Model: Iris/Lilac 3bin Sorter			Date: 11-Dec-01		1	No.: MA849001	
Modified Article: Antistatic Brush			Prepared by: M.Tsuyuki				
From: Technical Services Dept., GTS Division							
Reason for	☐ Parts catalog correction	☐ Vendor change ☐ To improve reliability		ange	☐ To m	neet standards	
Modification:	☐ To facilitate assembly			()		
	☐ Part standardization	Othe	r

Modification Bulletin

Model: Iris/Lilac 3bin Sorter Date: 11-Dec-01 No.: MA849001

Old part number	New part number	Description	Q'ty	Int	Page	Index	Note
AA120027	A8491661	Antistatic Brush	4	X/O	7 9 11	15 24 3

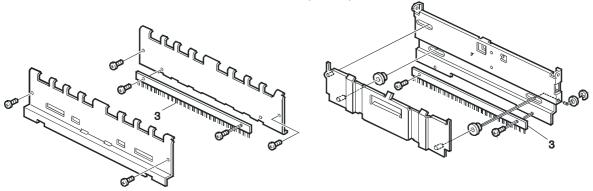
The Antistatic Brush has been modified so that the fibers remain firmly attached to the brush, which will ensure that SC410 is not triggered when paper is re-fed from the bypass tray to print the 2nd side.
